**City of Phoenix**  
PLANNING AND DEVELOPMENT DEPARTMENT

**Staff Report: Z-41-21-7**  
September 10, 2021

<b><u>Laveen</u> Village Planning Committee Meeting Date</b>	September 13, 2021
<b><u>Planning Commission</u> Hearing Date</b>	October 7, 2021
<b>Request From:</b>	<u>S-1</u> (Approved <u>C-2/CP-GCP</u> ) (14.56 acres)
<b>Request To:</b>	<u>C-2</u> HGT/WVR DNS/WVR (14.56 acres)
<b>Proposed Use</b>	Multifamily residential with a height and density waiver
<b>Location</b>	Approximately 615 feet north of the northwest corner of 59th Avenue and Dobbins Road
<b>Owner</b>	The Williams Family Living 1996 Trust
<b>Applicant</b>	Anne Healy, P.B. Bell
<b>Representative</b>	Manjula M. Vaz, Gammage & Burnham, PLC
<b>Staff Recommendation</b>	Approval, subject to stipulations

**Proposed Site Plan**  
**Source: BMA Architecture**

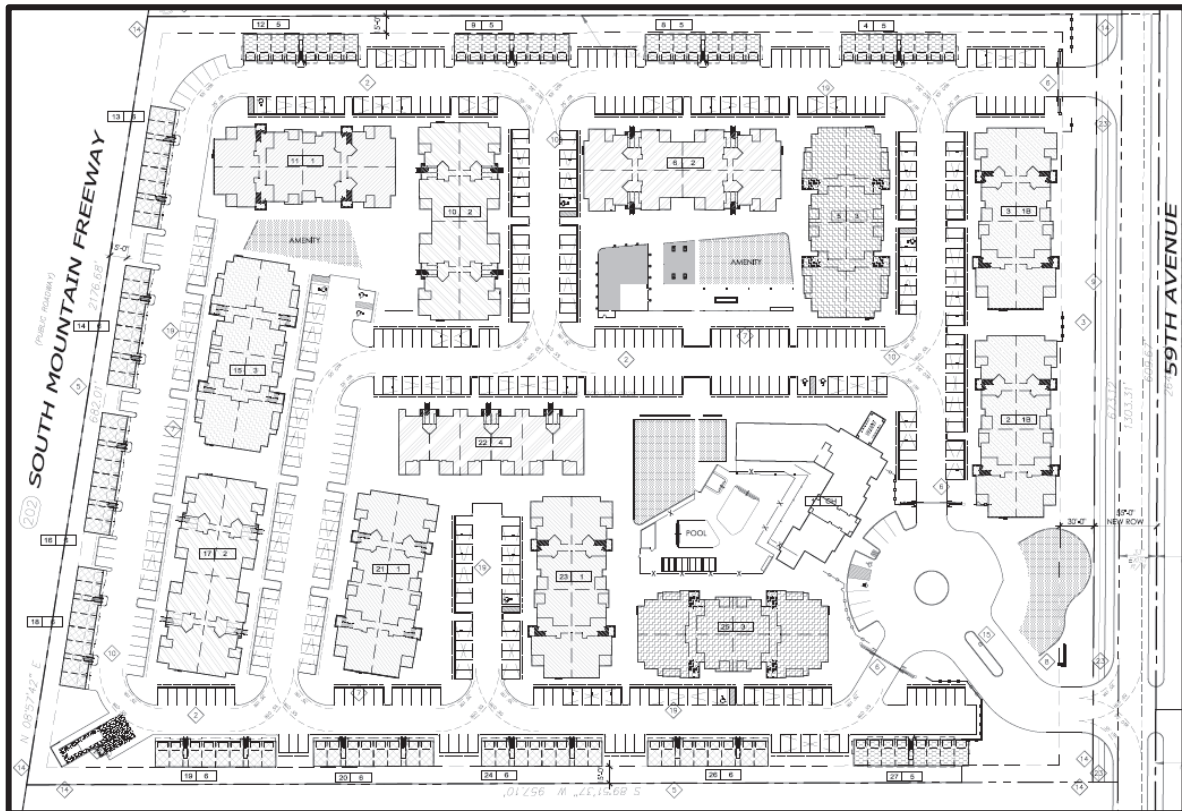
5. The proposed site plan depicts a multifamily residential development consisting of a mix of building types ranging from one to three stories in height, and residences ranging from one to three bedrooms units. The development proposes two vehicular entry drives along its 59th Avenue frontage. The southernmost driveway contains a roundabout style driveway entry that connects to two separate gated vehicular entries into the development. This driveway area will also have guest parking spaces with pedestrian access to the leasing office and clubhouse. The site plan depicts several desirable site design elements and amenities, which are further reinforced through staff recommended stipulations (discussed below). As such, staff is recommending general conformance to this site plan, per Stipulation No. 1.

**Proposed Site Plan**  
**Source: BMA Architecture**

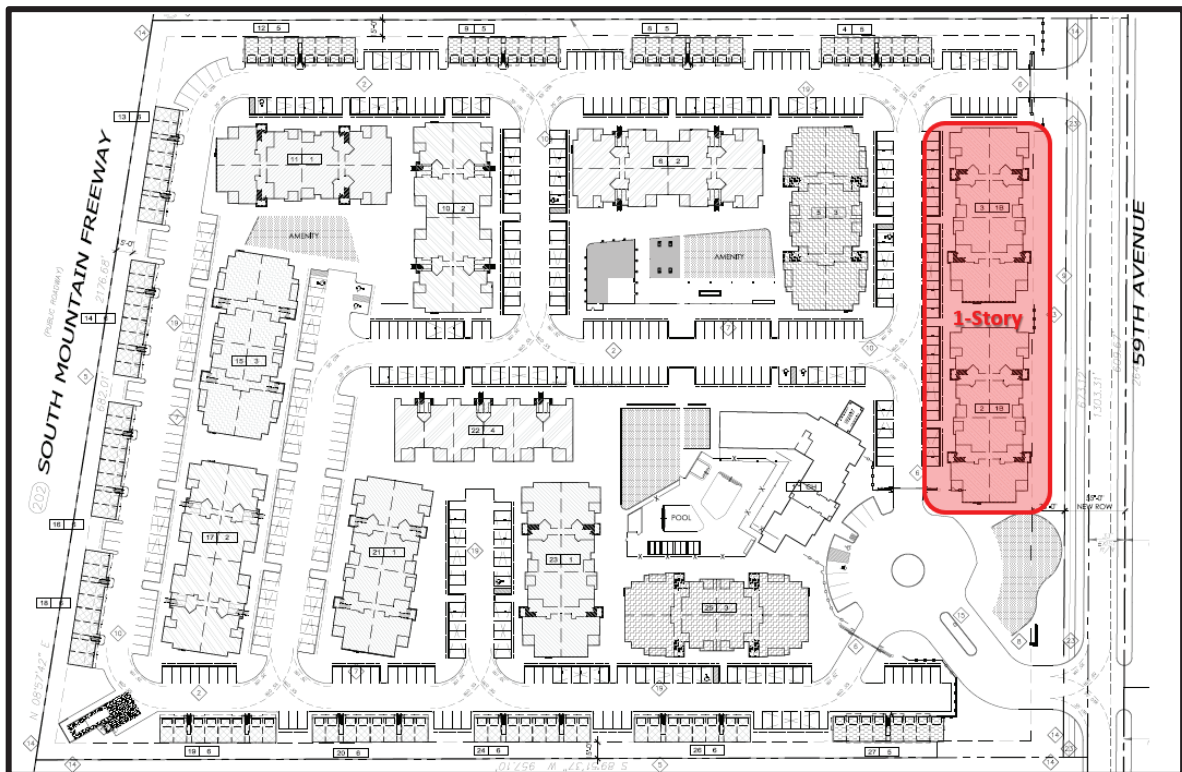
As noted in Background Item No. 3, the property to the east of the site, across 59th Avenue, consists of a single-family residential neighborhood with mostly single-story residences. To ensure an appropriate height transition as one moves west towards the Loop 202 freeway, staff is recommending that the buildings adjacent to 59th Avenue be restricted to a maximum building height of 2 stories and 30 feet, and all other buildings to a maximum of 3 stories and 40 feet. This is depicted on the proposed site plan and is addressed in Stipulation No. 2.

To further ensure an appropriate transition from the single-family residential community to the west, staff is recommending that a minimum 30-foot-wide landscape setback be provided along 59th Avenue. Within the streetscape setback, staff is recommending that large caliper trees be planted to provide both shade for pedestrians and a vegetative buffer between this site and the homes across the street. This is addressed in Stipulation No. 4. The site is also located along a planned trail as depicted in the city's Parks and Trails Map. This will be provided via a 10-foot-wide public Shared Use Path (SUP) along 59th Avenue and will be detached. Staff is recommending that the landscape strip between the SUP and back of curb be planted with minimum two-inch caliper trees, vegetation to prevent

mid-block crossings, and that a minimum of 75 percent shade be provided along the path at maturity. These recommendations are addressed in Stipulation No. 3.

Staff is also recommending enhancements to the primary entry drive on the southeastern portion of the site. These enhancements shall include a pedestrian connection between the interior of the development and the public sidewalk, which shall be detached from the vehicular driveway and lined with landscape areas of no less than five feet in width along both sides, planted with a mixture of ornamental trees, shrubs and flower beds. Further, staff is recommending that the entire driveway surface (outside of the community access gates) be constructed of a material other than that used to pave the parking surfaces. These recommendations are addressed in Stipulation No. 6.

Additional improvements to the streetscape are recommended by staff, including the utilization of open fencing along 59th Avenue, or a combination of solid masonry and wrought iron open view fencing, as well as decorative ranch rail fencing elements to reflect the agricultural heritage of Laveen. These are addressed in Stipulation No. 7 and 9.

The proposed site plan depicts a minimum 15-foot landscape setback along the north, west and south perimeter property lines. Staff is recommending that these perimeter landscape areas be landscaped with minimum 2-inch caliper trees to buffer from adjacent properties, as well as with minimum 75 percent live groundcover. This is addressed in Stipulation No. 5. Staff is also recommending enhanced perimeter wall design around the property, per Stipulation No. 8.
